Access Compliance Report

Public Rights-of-Way

(Curb Ramps)

Intersection ID: 10035850	Main Street: RESOLVES_LN	Cross Street: N/A	Location: SW
ADA ID: 364CCDAE502C	Ramp Type: Perp	Initial Pass/Fail: Fail	Overall Compliance: No
		Severity Score: 37.5

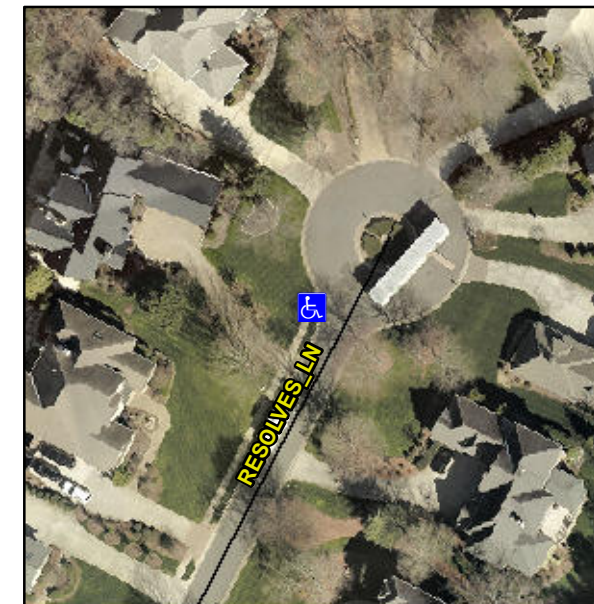
Not Found, R304.2.2, R304.5.3

Compliance	Description	Data	Compliance	Description	Data
N/A	Ramp Length (in)	47.0	No	Ramp Slope (%)	8.8
Yes	Ramp Width (in)	48.0	No	Ramp XSlope (%)	8.6
N/A	Flare Type LT	N/A	N/A	Flare Type RT	N/A
N/A	Flare Slope LT (%)	N/A	N/A	Flare Slope RT (%)	N/A
N/A	Flare Traversable LT?	N/A	N/A	Flare Traversable RT?	N/A
N/A	Landing Length (in)	N/A	N/A	DWS Provided?	N/A
N/A	Landing Width (in)	N/A	N/A	DWS Contrast?	N/A
N/A	Landing Slope (%)	N/A	N/A	DWS Length (in)	N/A
N/A	Landing X Slope (%)	N/A	N/A	DWS Full Width?	N/A
N/A	Landing Curb? (Y/N)	N/A	N/A	DWS Offset (in)	N/A
N/A	Shared Landing?	N/A			
N/A	Gutter Ponding?	N/A	N/A	Gutter Slope (%)	N/A
N/A	Gutter Lip Ht (in)	N/A	N/A	Gutter X Slope (%)	N/A
N/A	Painted X Walk1?	No	N/A	Painted X Walk2?	N/A
	X Walk 1 Direction	To SE		X Walk 2 Direction	N/A
N/A	X Walk 1 Width (in)	N/A	N/A	X Walk 2 Width (in)	N/A
	X Walk 1 Slope (%)	2.6		X Walk 2 Slope (%)	N/A
	X Walk 1 X Slope (%)	4.5		X Walk 2 X Slope (%)	N/A

Remove & Replace Entire Ramp.
